**Planning Commission Meeting Agenda**

## Planning Commission Staff Report

**Subject:** 114 South Main Street Infill  
(Class A Development, Preliminary Hearing; PL-2023-0077)

## CLASS A PRELIMINARY - REVISION 2

1 PROPOSED SITE PLAN & LANDSCAPE PLAN  
SCALE: 1" = 10'-0"

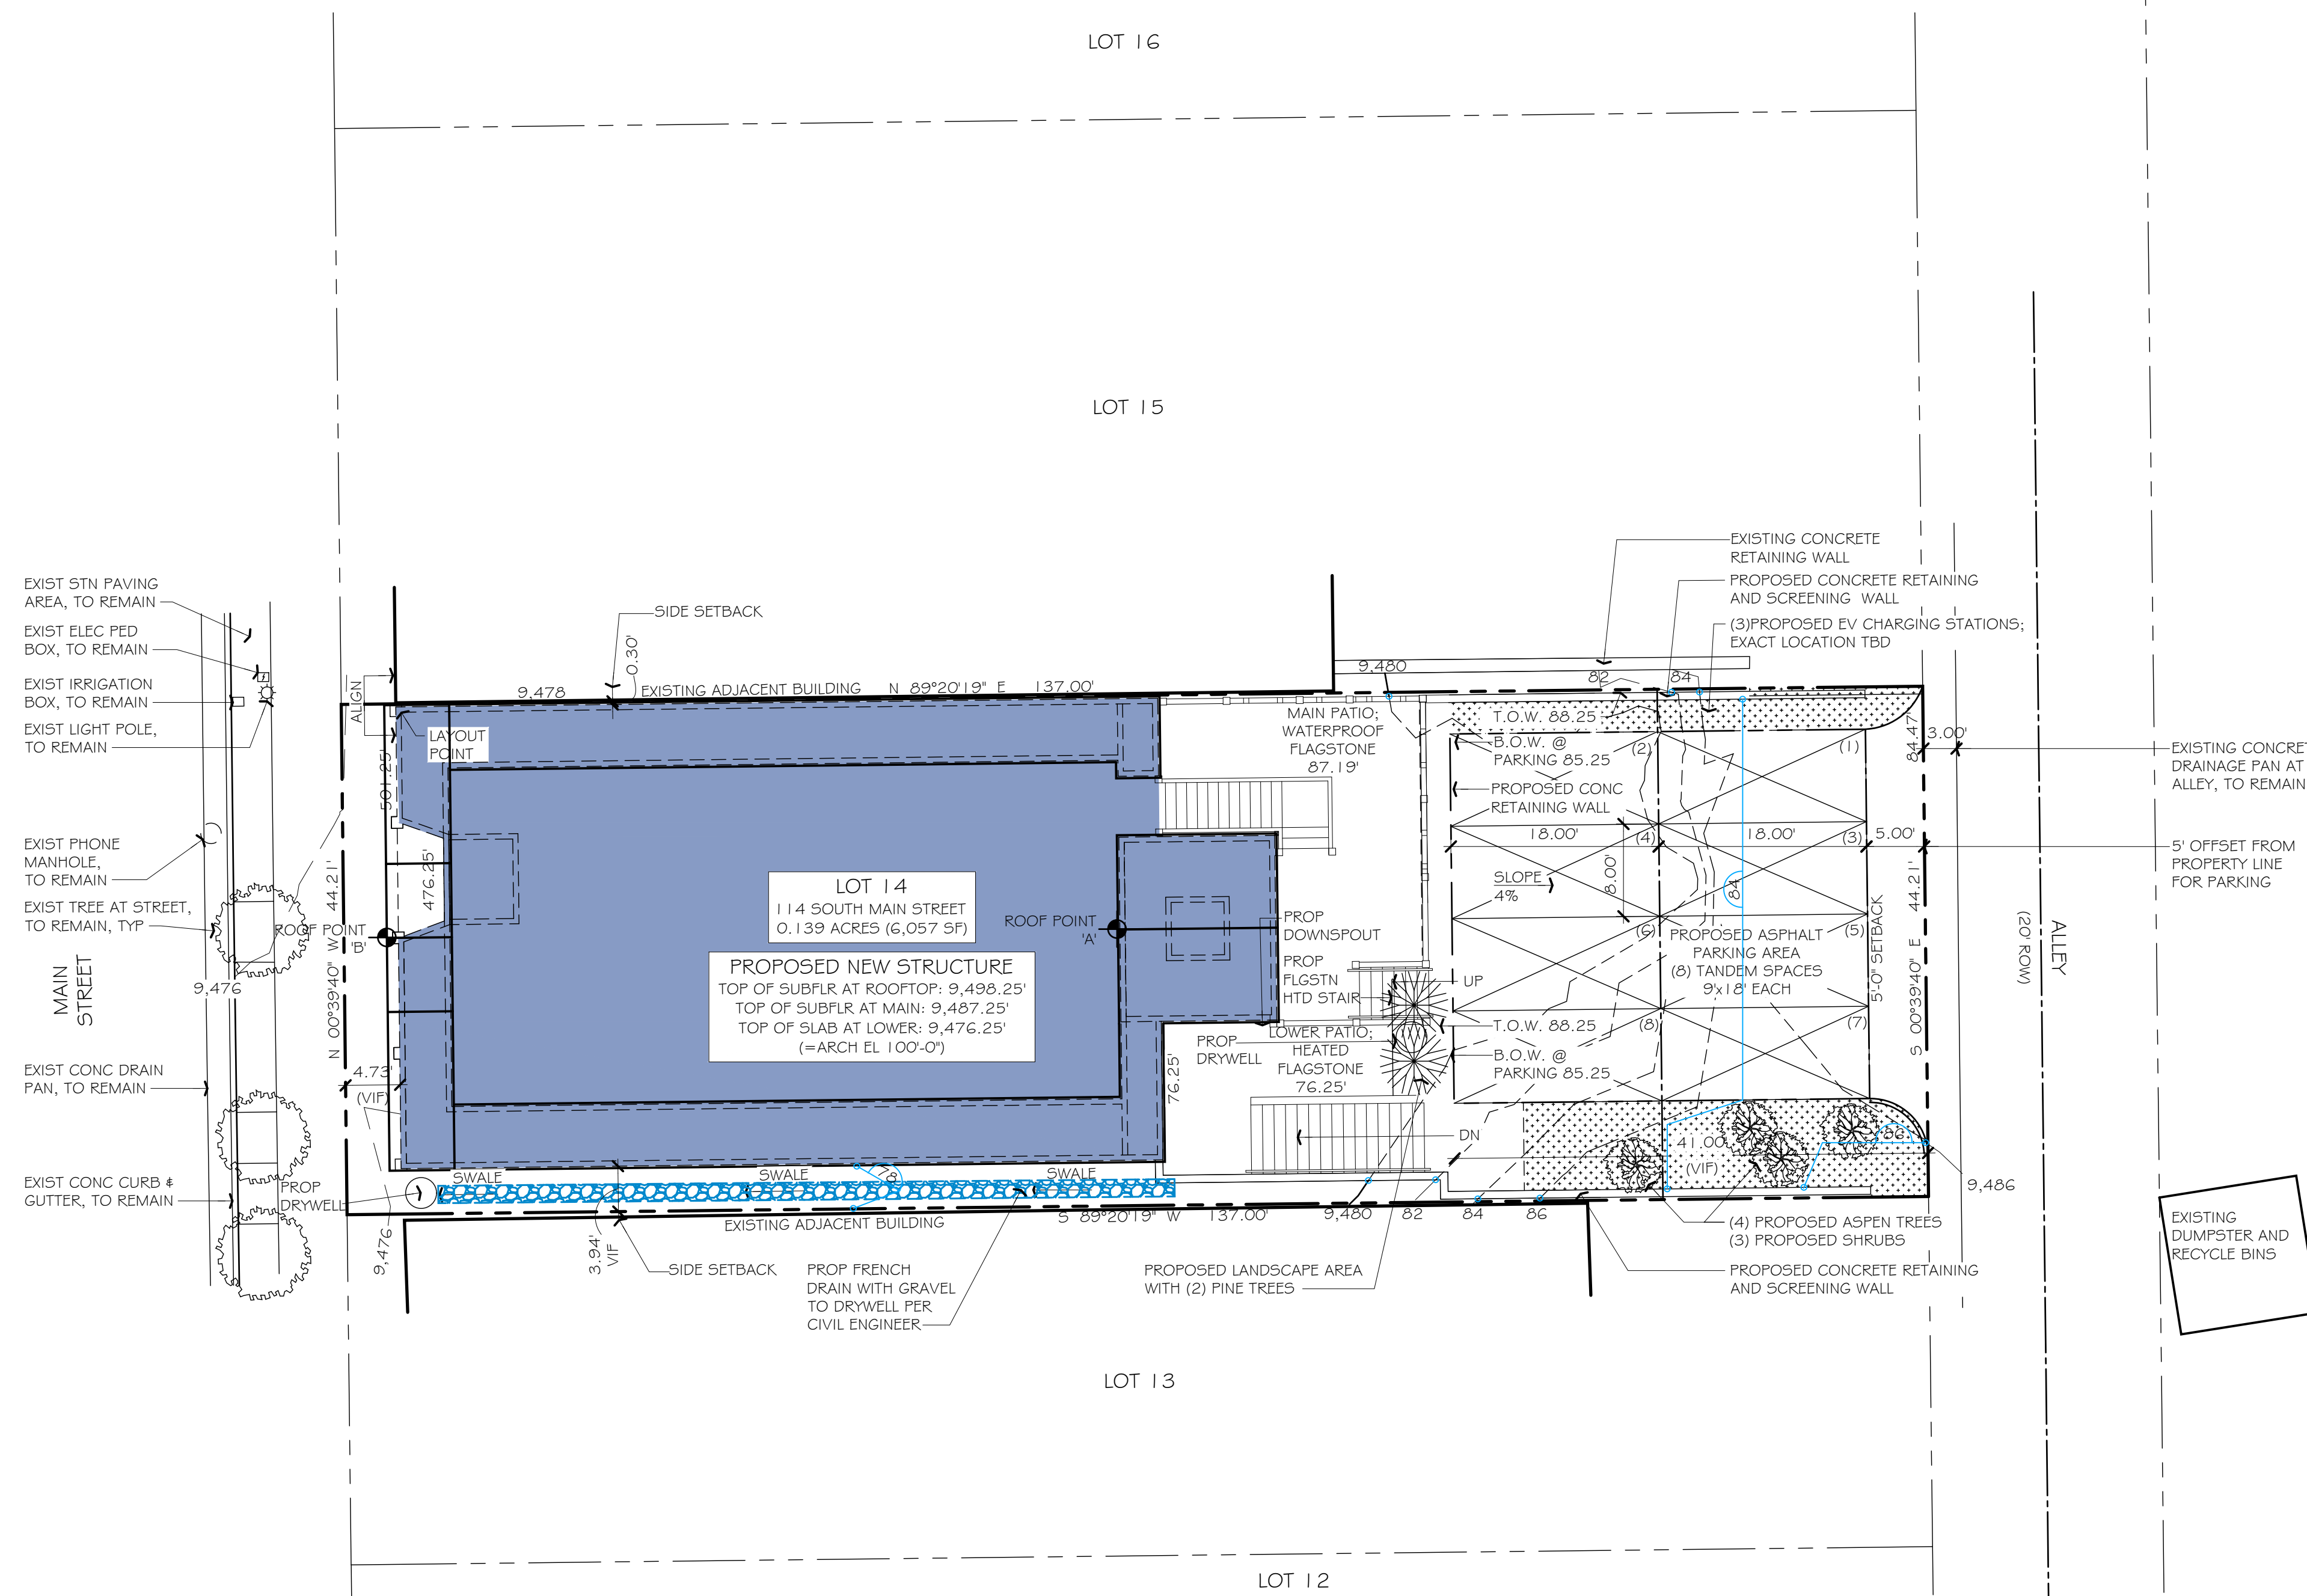
Site Plan: The overall site plan remains the same as from the first preliminary hearing. The project follows the historic settlement pattern for this block (Priority Design Standard 4). It also matches the Town grid (Priority Design Standard 5). Staff believes that the new construction reinforces the unity of the block (Priority Design Standard 8).

The placement of the structure with a 0' front setback at Main Street maintains the established historic setback (Priority Design Standard 89). All parking is located at the rear of the lot. Landscaping (Design Standard 213) has been kept to a minimum along the street edge to be harmonious with the functions of the Core Commercial Character Area. There is no new proposed landscaping in the front. Existing trees in the public right-of-way at the street level will be retained. Some landscaping is proposed in the rear to screen the rear patio and parking from the lot to the south.

**Energy Conservation (33/R):** The applicant is proposing 3 EV chargers to be installed in the rear parking area for an additional positive three (+3) points. The proposal includes 310 sq. ft. of heated paving which warrants negative one (-1) point under the Development Code at the time of application.

1 WEST ELEVATION  
SCALE: 1/8" = 1'-0"

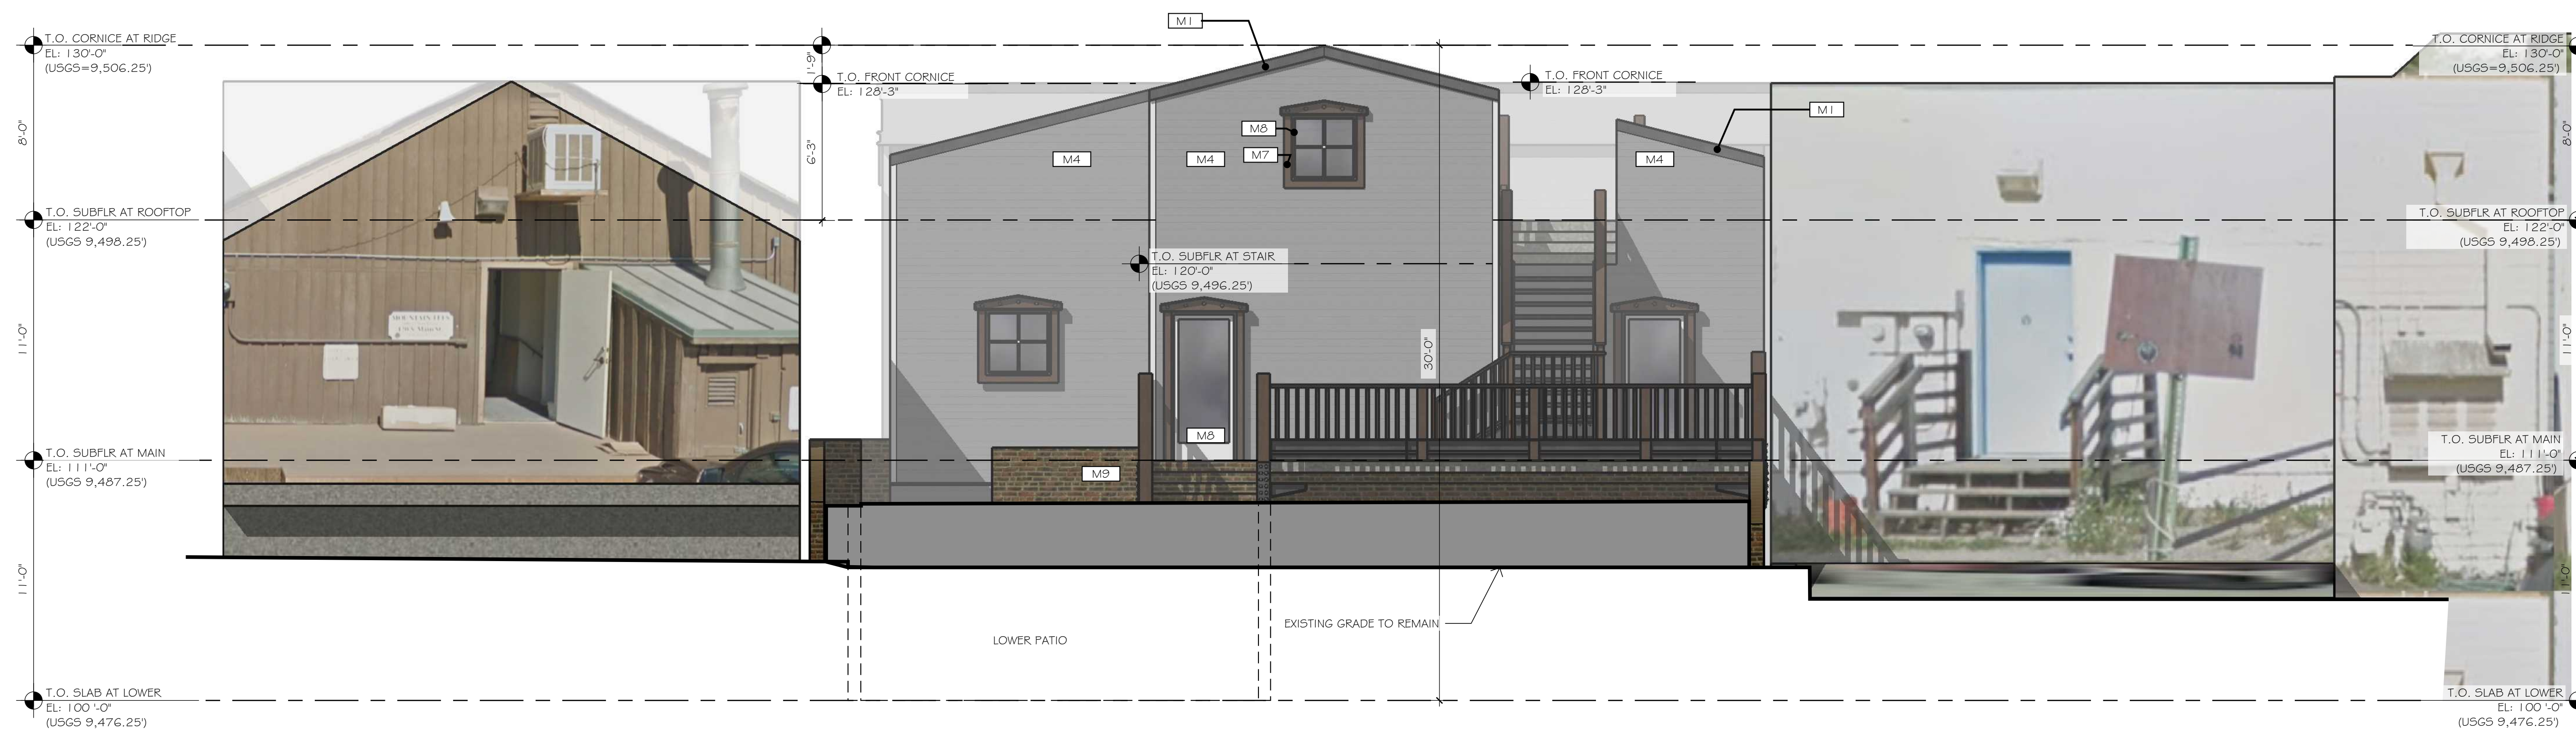
2. Upper-level windows – the front façade upper-level windows have been revised to have fewer muntins for a simpler look.
3. Building height – the building height has been increased from an overall height of 28.9' to 30' at the center point of the front cornice. This allows the building to be essentially even in height at the side parapet walls with neighboring buildings that are either historic or conform to the historic district standards.

5. Rear elevation – the previously proposed elevator tower on the north has been removed. The flat roof of the rear has been replaced with a centered gable roof which mimics the center point of the front cornice, to house the elevator and interior stairs now located in the center rear of the building. The rear shed roof over the porch has been removed. Rear exterior egress stairs have been moved from the south of the building to the north. The rear windows have been resized and relocated but maintain their previously proposed architectural style and materiality.

Measuring from the top of the front center cornice point the building measures 30' tall. The rear gable is even in elevation with this cornice point but due to the existing grade change from the front to rear of the lot which will remain, the rear of the building is approximately 5' shorter than the front. Staff believes this change allows the project to now meet the Priority Design Standard 219 requirement to step down in the rear.

At the previous hearing, the Commission recognized the contradiction between the Historic Design Guidelines Priority Design Standard 219 and the Development Code regarding building height. There was consensus that although the proposed height for the front parapet does not exceed the established historic height for this section of Main Street, the Commission would not waive points for the height of the front parapet. Therefore, the proposed height of 30' meets Priority Design Standard 219 but warrants negative five (-5) points under the Development Code Policy 6/R.
